Access Compliance Report Public Rights-of-Way (Curb Ramps)

Main Street: TERRASTAR_LN Cross Street: TETHER_MOON_LN Location: SW

ADA ID: RPAT211101100105 Ramp Type: Type 4 - Parallel Initial Pass/Fail: Pass Overall Compliance: No Severity Score: 6

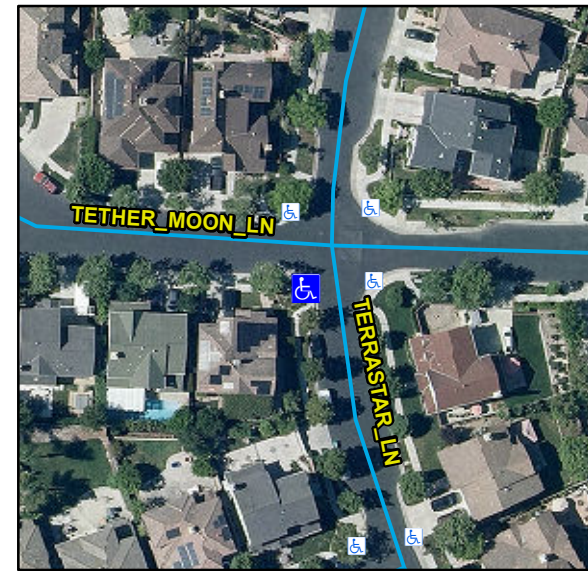
Crossing 1 Slope (%)	1		Crossing 2 Slope (%)	0.9
	Crossing 1 Cross Slope (%)	1.9		Crossing 2 Cross Slope (%)	2.4
Yes	Gutter Ponding	No	Yes	Curb Slope	5.2
Yes	Gutter Lip Height (in)	0		Road Run Slope (%)	1.6
No	Gutter Run Slope (%)	5.9		Road Cross Slope (%)	4.2
Yes	Gutter Cross Slope (%)	0	No	Perpendicular Joint Present	No
Yes	Overall Surface Condition	Acceptable			
	Cross Gutter Present?	No		Spandrel Present?	No
	Replace Cross Gutter?	N/A		Replace Spandrel?	N/A

Remove & Replace Curb Ramp With Two New Directional Ramps or Equivalent. Remove & Replace Gutter.
